NOTICE OF PUBLIC HEARING
Minor Variance

APPLICATION NO.:	SC/A-22:231	SUBJECT PROPERTY:	35 UPPER LAKE AVENUE, STONEY CREEK
ZONE:	R2 and OS (Residential Two; Open Space)	ZONING BY-LAW:	Zoning By-law former City of Stoney Creek 3692-92, as Amended

PURPOSE & EFFECT: To permit the construction of an addition in the Northerly and Southerly side yards and a front porch expansion in the front and Northerly side yard

Proposed Site Plan
Scale 1:400

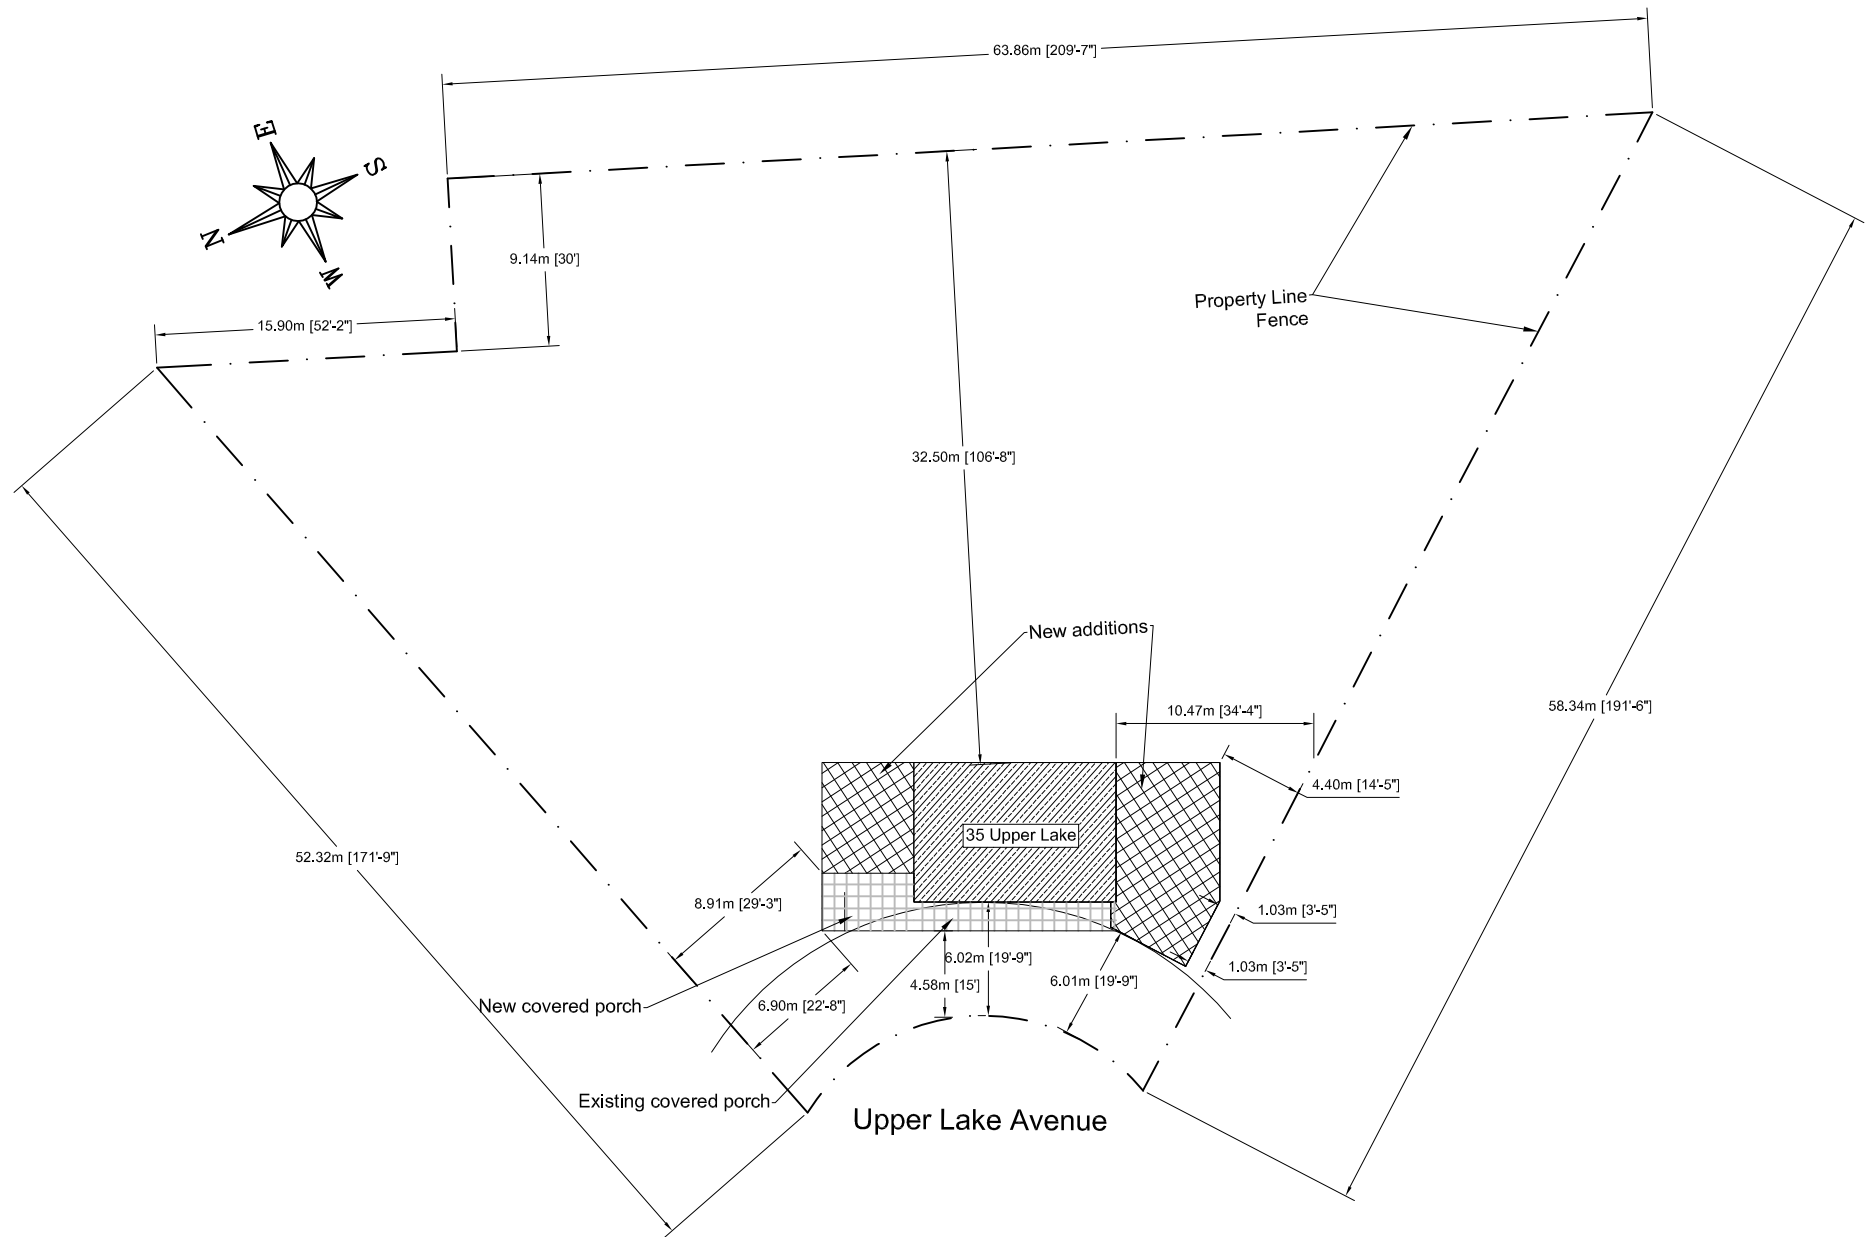
1. Insufficient information has been provided for parking within the proposed garage and the driveway within the front yard. Section 6.3.4 of Stoney Creek Zoning By- Law 3692-92 requires a minimum number of two (2) parking spaces per dwelling of which only one may be provided in the required front yard. Tandem parking is permitted. Parking spaces within the attached, private garage shall be 6.0 m x 3.0 m. The proposed garage does not appear to provide ample space for the required parking space. As such, a variance has be added to address this.

2. Be advised, as per Section 4.10.2 b) of Stoney Creek Zoning By-Law 3692-92, any parking space other than a 90 degree parking space shall have a width of 3.0 m and a length of 6.0 m. Insufficient information has been provided regarding parking spaces on the driveway. Should the parking space within the driveway not meet the required dimensions of a parking space, additional variances may be required.

3. Insufficient information has been provided for the front porch stairs. An unenclosed porch, including the stairs, may project into any required front yard 1.5 metres. It appears that the proposed front

porch stairs encroach beyond the maximum permitted 1.5 metres. Should the porch and stairs encroach further than the permitted 1.5 metres, additional variances may be required.

4. Be advised, a portion of the property is within the OS (Open Space) zone which does not permit a Single Family Dwelling or Uses, Buildings or Structures accessory to the Single Family Dwelling use. Insufficient information has been provided regarding the location of the proposed addition(s) to the Single Family Dwelling in relation to the Open Space zone. Should any portion of the proposed expansion to the Single Family Dwelling be within the Open Space zone, additional variances may be required.
